**Planning Commission
Staff Report**

December 11, 2013
Item 6.a.

- SUBJECT:** P13-2028
- APPLICANT:** Anil and Divya Reddy
- PROPERTY OWNER:** Anil and Divya Reddy
- PURPOSE:** Application for Design Review Approval to evaluate the conformance of an existing single-family residence in the Ruby Hill Development to the Ruby Hill Architectural Design Guidelines.

- LOCATION:** 3737 West Ruby Hill Drive
- EXHIBITS:**
- A. Draft Conditions of Approval for P13-2025, dated December 11, 2013.
 - B. [Excerpts of the Building Permit Plans, dated “Received September 30, 2013.”](#)

Figure 9, Garage 1, Garage 2, and the Storage Area adjoining Garage 2.

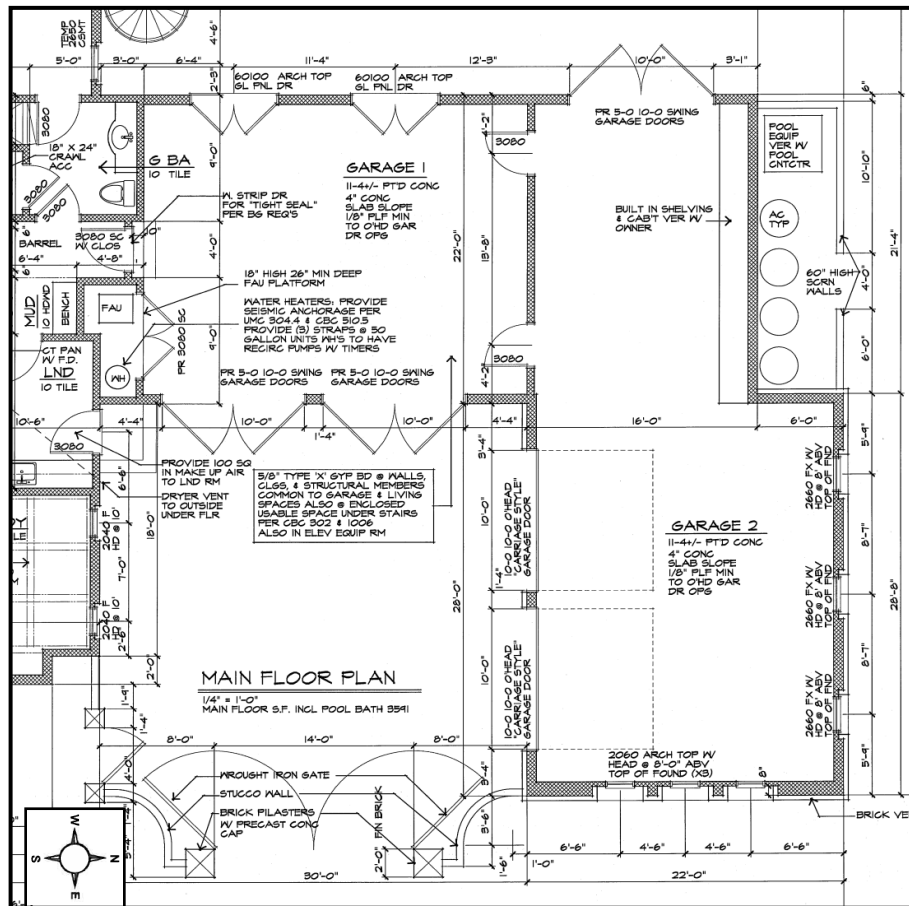
Two, two-car garages are shown on the building permit plans designated as Garage 1 and Garage 2 on the building permit plans. The garages are arranged in an L-shaped pattern on the north and south sides of the auto court. Garage 1 was approved with two swing-out garage doors and Garage 2 was approved with two sectional roll-up doors. Both sets of doors were shown on the building permit plans as solid wood doors with recessed wood panels and without window glass. A storage area accessible to Garage 1 and Garage 2, with two swing-out doors facing the applicants' rear yard, is shown on the building permit plans.

The applicants constructed Garage 2 with the sectional roll-up garage doors shown on the building permit plans and constructed Garage 1 as living area with marble tile floors and with two swing-out glass doors with decorative iron work and gold-color handles and door jambs. The glass doors are 10 feet in width, which exceeds the minimum 8-foot width required by the California Building Code for a single-car garage door. (Staff notes the California Building Code does not prohibit glass garage door(s) provided the glass is tempered according to California Building Code requirements.)

The RHADC required the applicants to comply with the RHADG: provide the three minimum garage spaces and replace the glass garage doors with solid wood doors. Representatives of the RHADC have also stated that the arched openings of the present garage doors can remain provided that the glass doors are replaced with solid wood doors.

Staff concurs with the RHADC that a two-car garage and the glass garage doors do not comply with the RHADG.

As conditioned, the applicants are required to use Garage 1 as a two-car garage to park their vehicles and to replace the glass garage doors with solid wood doors matching the design and colors of the garage doors on Garage 2 in compliance with the RHADG. The arched garage door openings may remain with the trim around the doors repainted to match the trim color around the two rectangular doors. The applicants are required to submit the revised door designs and colors to the RHADC for review and approval before the plans are submitted to the Building Division.

Figure 10, Garage 1 Swing-Out Garage Doors.

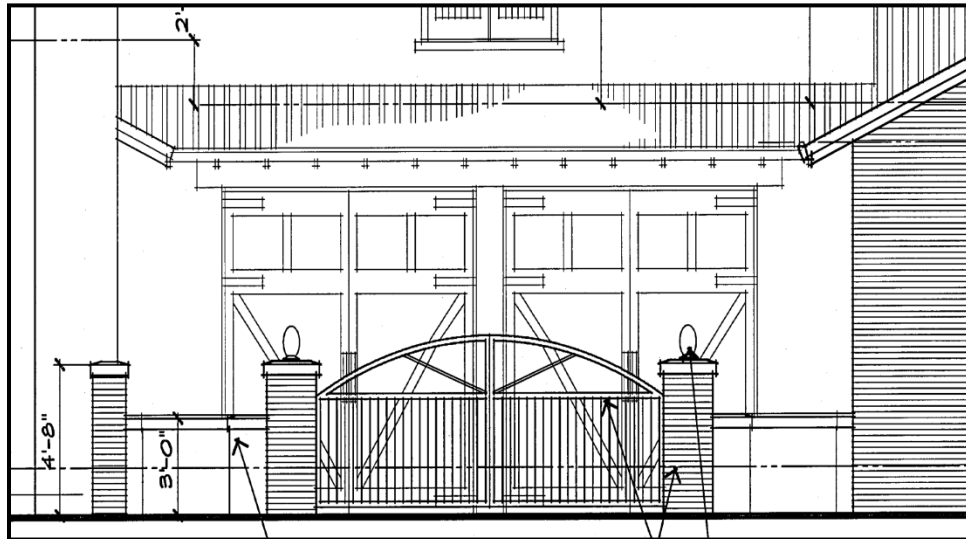
Staff discussed replacing the garage doors with the applicants. The applicants prefer to keep the doors as installed due to their cost; the garage doors match the design of the front entry doors; their belief that they are consistent with the design concept of their residence; and because the applicants believe that there is precedent for the glass garage doors based on the above-described custom home in the Ruby Hill Development.

Figure 14, Front Entrance Door.

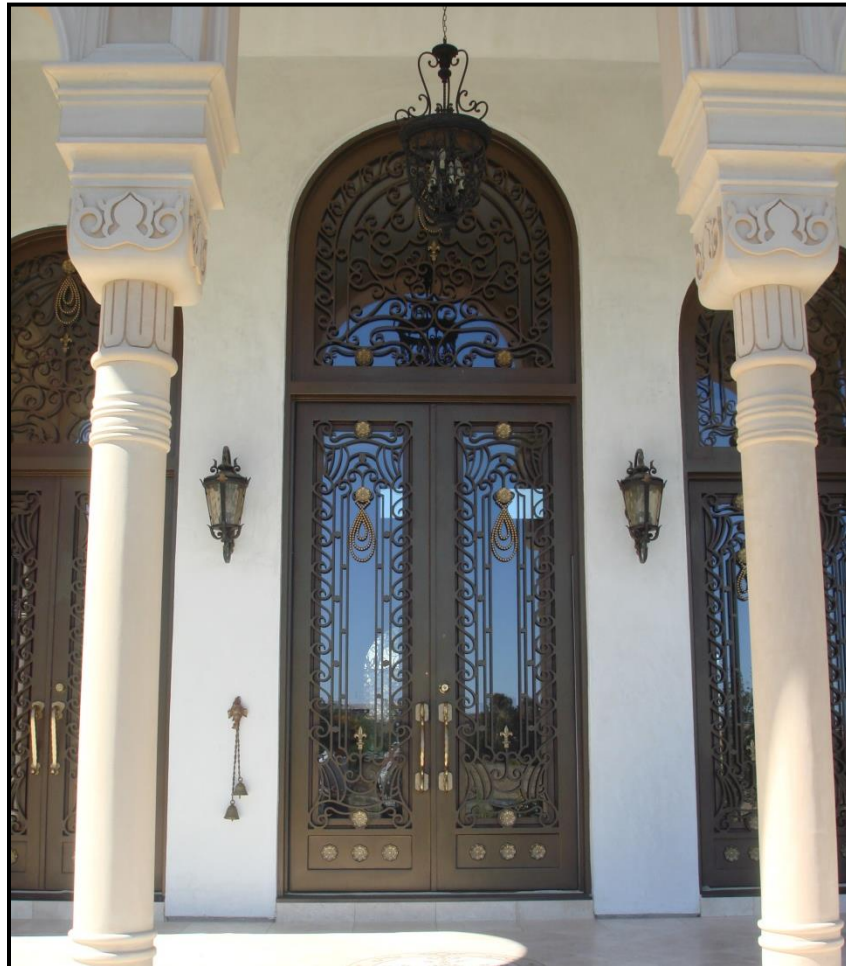
windows set above each pair of doors. Instead of installing the originally proposed and approved wooden doors, the applicants installed glass doors with very ornate decorative iron work, gold-colored door handles and hardware, and with the door trim painted gold to match the door hardware.

The RHADC approved the originally proposed three pairs of front doors for the applicants’ home based on the previous approvals in the Ruby Hill Development for custom homes with multiple front doors, and because the original door designs proposed by the applicants were consistent with the Monterey/Spanish Eclectic style.⁶ The RHADC prefers to have the front doors replaced with doors that are less ornate in their appearance. The applicants prefer to keep the doors as installed based on the design concept for their home and because they believe there is precedent in the Ruby Hill Development.

Staff concurs with the applicants that the front entrance doors comply with the RHADG and that they are consistent with the number and appearance of front entrance doors in the Ruby Hill Development. The three pairs of front doors on the applicants’ home are

Allow the front entrance doors to remain as installed.

Figure 20, Column/Capital Detail on Building Permit Plans

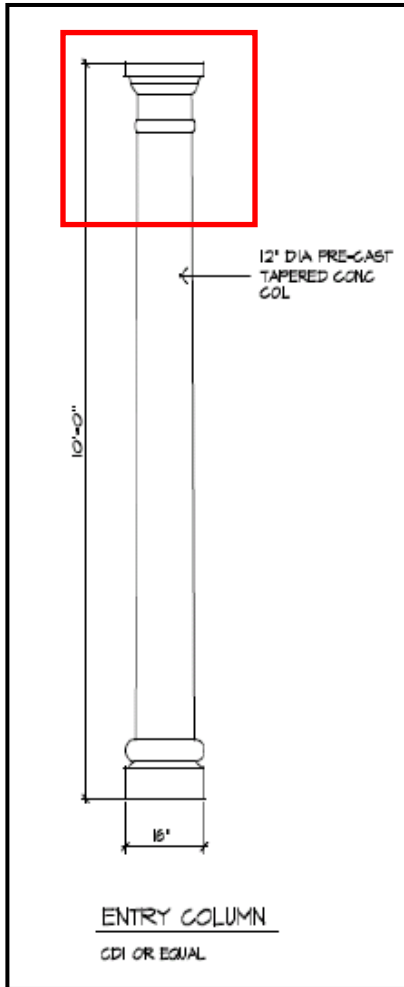
The RHADC approved a Tuscan style capital on the building’s columns. The applicant installed capitals that the RHADC considers to be too ornate and, therefore, not consistent the Monterey/Spanish Eclectic style of the RHADG.

The RHADC's position is that the capitals be replaced with the simpler-style capitals shown on the building permit plans. The applicants prefer to keep the capitals as installed as being consistent with the design concept and because they believe that there is precedent in the Ruby Hill Development.

Staff concurs with the applicants on this issue. The capitals installed on Ruby Hill homes vary from simple to ornate in appearance. While the capitals on the applicants' home are ornate in their appearance, staff considers them acceptable as there are no design guidelines that prohibit them.

Staff Recommendation.
Allow the capitals to remain as installed.
